## 10.2 Turbine Generator

The information in this section of the reference ABWR DCD, including all subsections, tables and figures, is incorporated by reference with the following departures and supplements.

Figure 10.2-1 Turbine Stop Valve Closure Characteristic

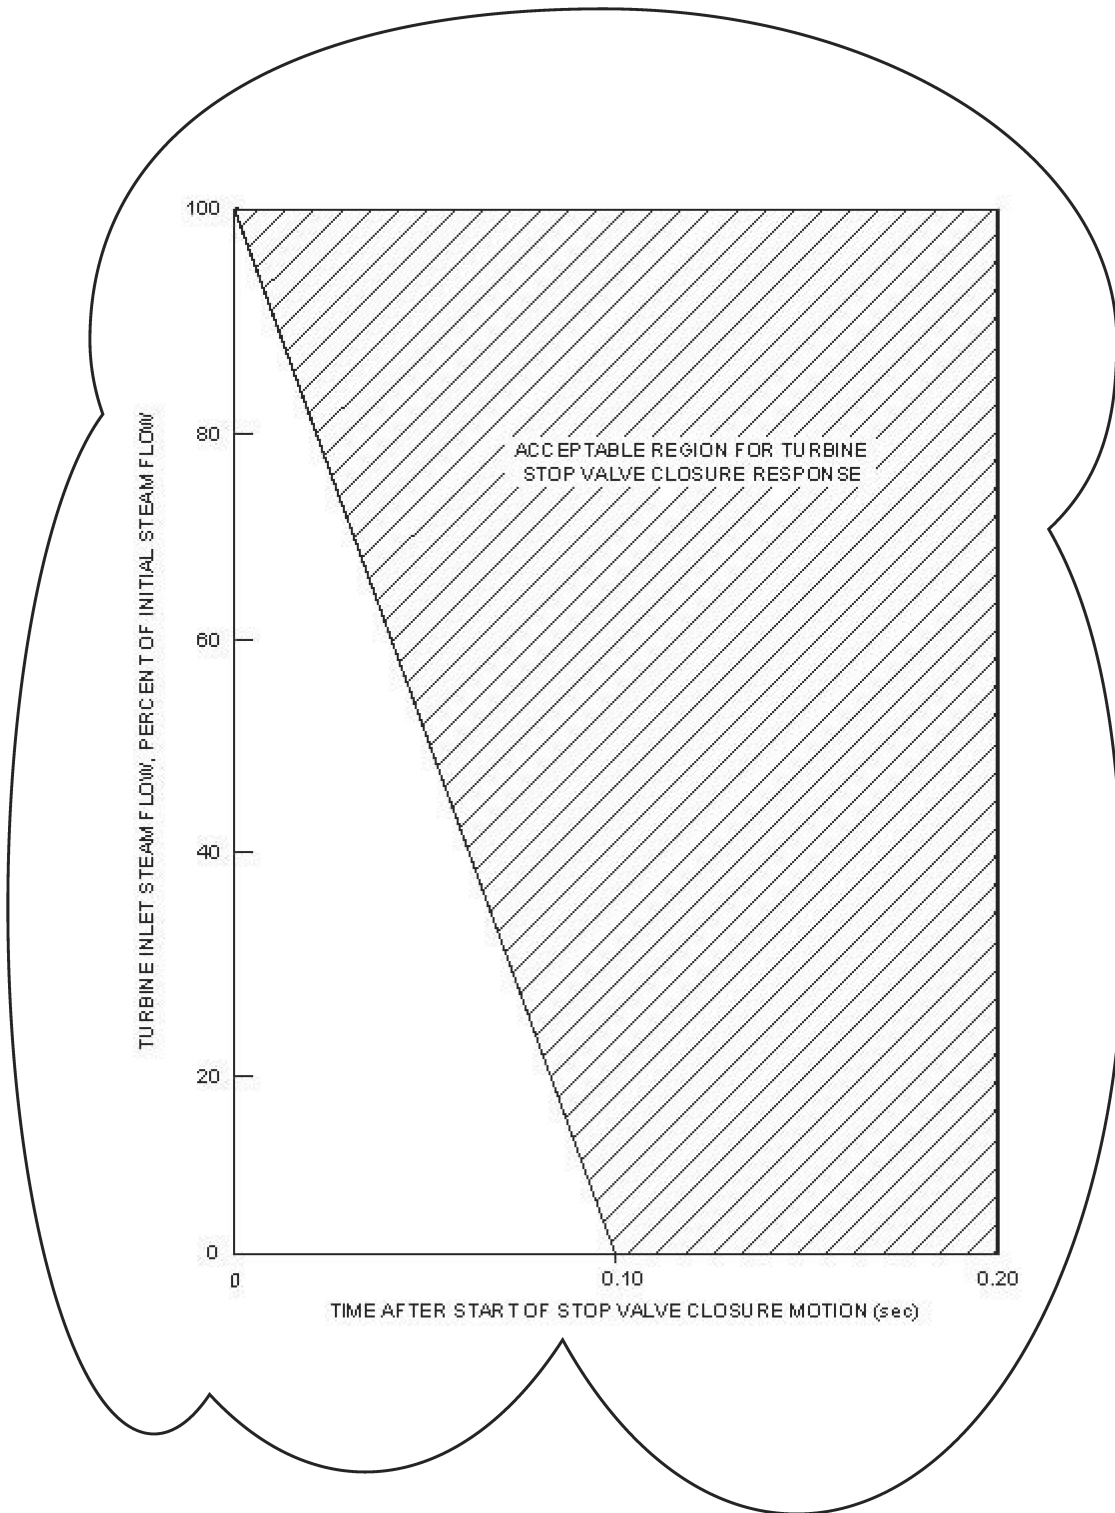
STD DEP Admin (Figure 10.2-1)
